GOVERNMENT OF THE DISTRICT OF COLUMBIA
OFFICE OF PLANNING

MEMORANDUM

TO: Zoning Commission
FROM: *HLS PV*
Harriet Tregoning, Director
DATE: March 16, 2007
SUBJECT: Zoning Commission Case #06-03, New Office Building at 100 M Street SE, pursuant to the Capital Gateway Overlay District – request for modifications to the approved plans

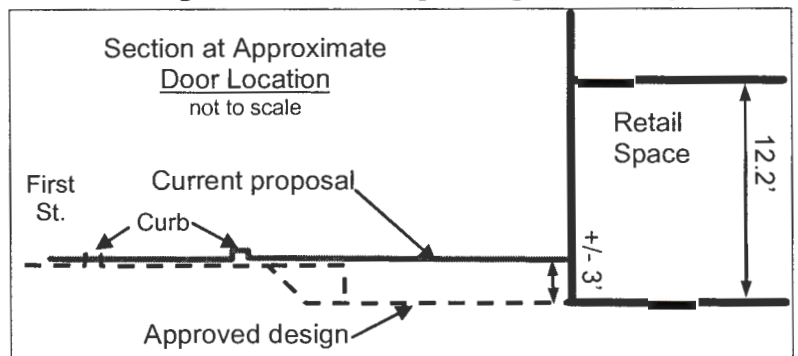
First Street SE slopes up from south to north in front of the proposed building. The approved application addressed this change in grade by providing a flat area adjacent to the building at essentially the same elevation as the interior floor level, with planters and steps to the sidewalk adjacent to the street which would follow the slope of the street.

This solution is no longer feasible, since the width of the area to work with to accommodate the slope has been reduced substantially. The applicant is now proposing that the entire sidewalk area slope up with the street, eliminating the sunken area and the related need for steps within the sidewalk area. In addition to the changes to the streetscape design (including the loss of opportunity for outdoor seating area), this results in a grade differential between the sidewalk and the interior floor level of as much as 3.5 feet at the north end of the building, or about 2.5 to 3 feet in front of the proposed door location – the floor of the retail space would be lower than the level of the sidewalk by this amount.

In discussions with OP, the applicant clarified that this change in grade would be accommodated through the installation of ramps and stairs within the building down to the retail floor level. This requires additional relief from the minimum floor to ceiling height of 14 feet for the landing areas. Landings, stairs, and ramps from the M Street entrance down to the retail level will also be required, although the grade differential is less at this location. While the change in grade from M Street to the retail area is shown on the approved set of site plans, this was not made clear to the OP, and the required landings, stairs, and ramps were not shown on the submitted plans.
